Attorney Docket No. 10123/00301 (03-008)

**REMARKS**

Appl. No. 10/630,885  
Amdt. Dated Feb. 14, 2008  
Reply to Office Action of Nov. 21, 2007  
Annotated Sheet Showing Changes  $\pm 1$

FIG. 2

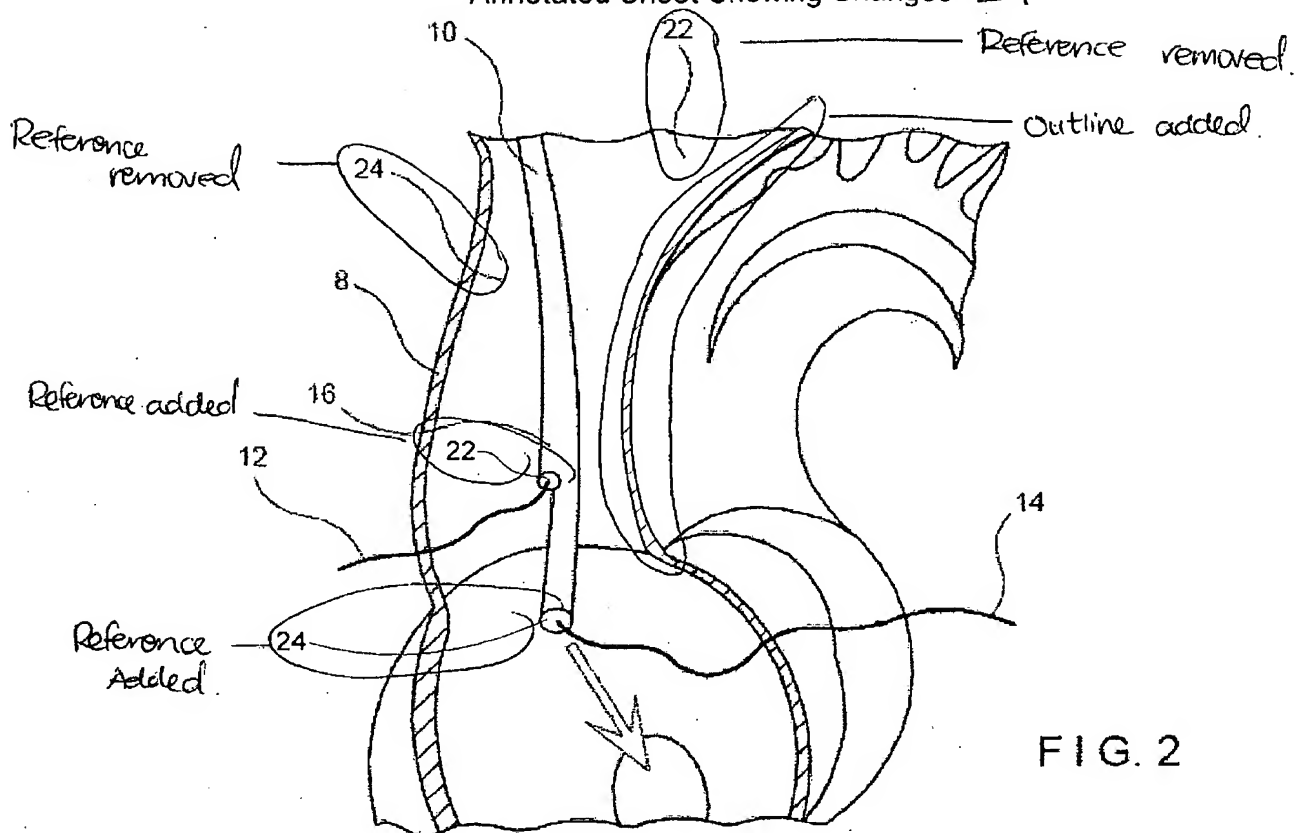
Figure 2 and 7 have been amended. Two sheets of Replacement Drawings are enclosed along with two Annotated Sheets.

The drawings stand objected to under 37 CFR 1.83(a). In support of the rejection, the Examiner stated that the features of claim 6 are not shown in the drawings. (See 11/21/07 Office Action, p. 2). Claim 6 is directed to a "second lumen [of the first housing] ... wherein a second flexible disk extends across the second lumen." Figure 2 of the drawings has been amended to indicate the positions of the lumens 22 and 24. In light of this amendment, it is respectfully submitted that the drawings comply with all requirements and withdrawal of this objection is requested.
